Bath & Body Works

**STORE 737
SPACE 235
SOUTH HILL MALL
3500 SOUTH MERIDIAN STREET
PUYALLUP, WA 98373**

Submittal Date: 01/10/23
Plan Issue/Rev Date: _____
Acct Rep: Ashley Abney
Designer: Jaye Williams

C FACE LIT CHANNEL LETTERS - ELEVATION
Scale: 1 1/2" = 1' - 0"

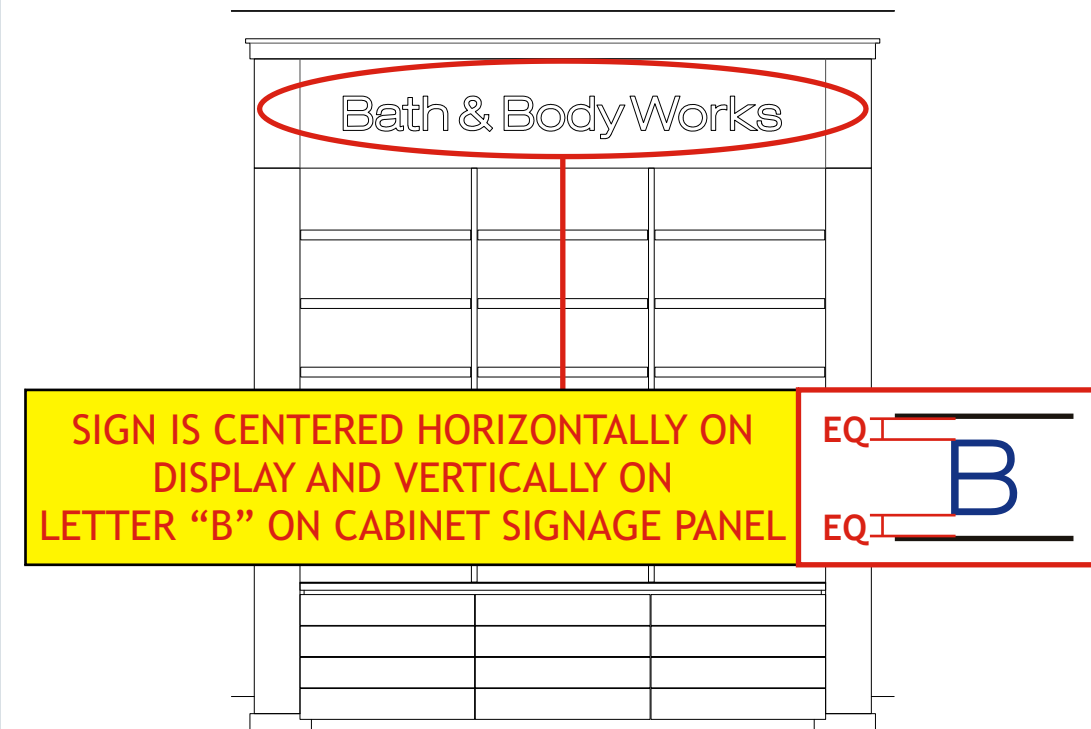
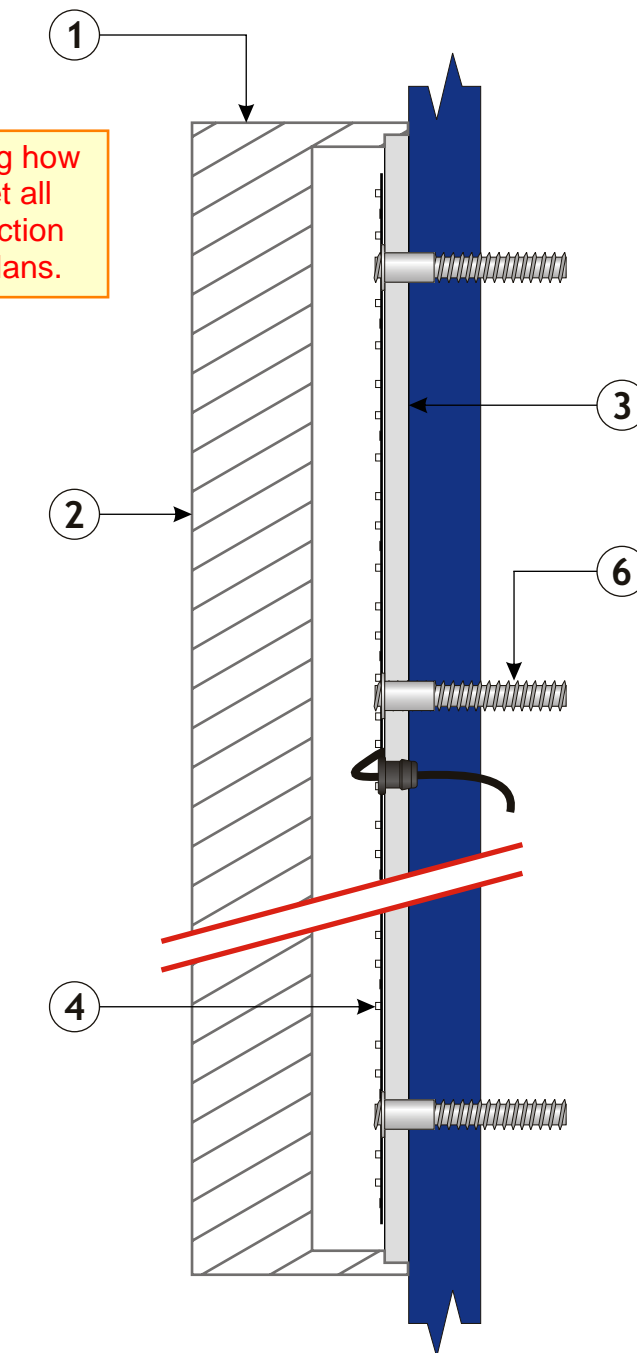
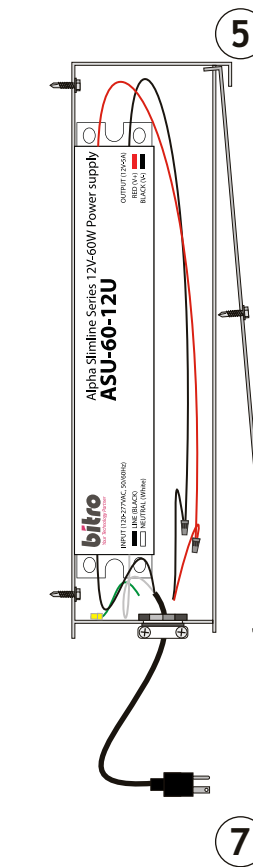
Must provide information showing how the signs located in the mall meet all the requirements of 2018 IBC section 402.6.4. Note on page 8 of the plans.

D EDGE LIT - ILLUM CHANNEL LETTERS - ELEVATION
Scale: 1 1/2" = 1' - 0"

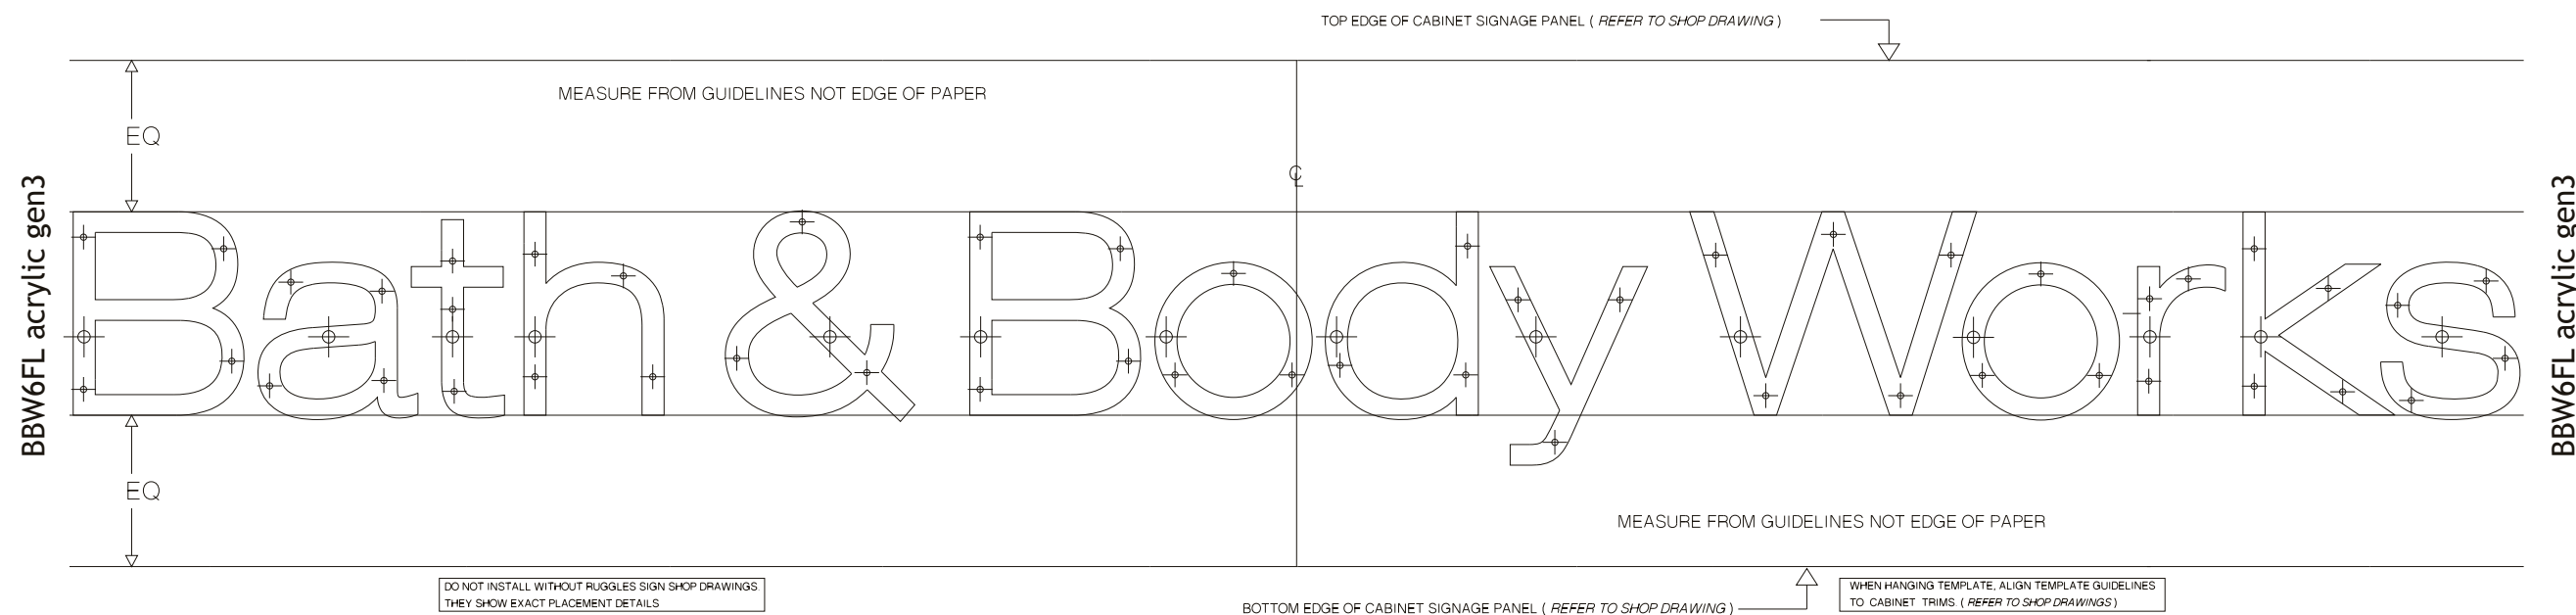
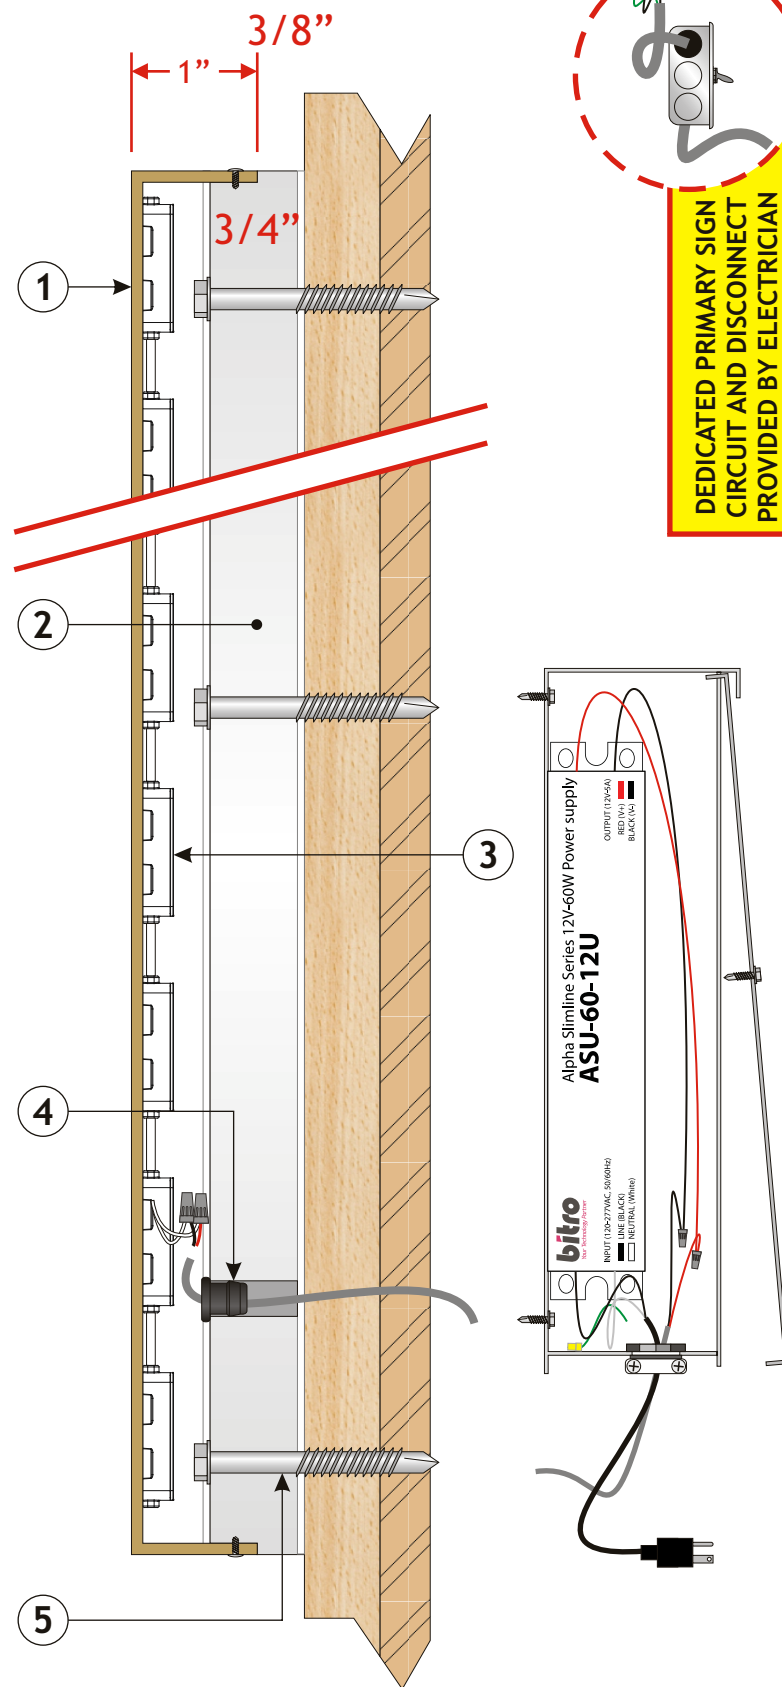
Need to more clearly depict the spacing and actual location of all mounting anchors so the inspectors know exactly what they are looking at on site and for review. Note on page 9 of the plans.
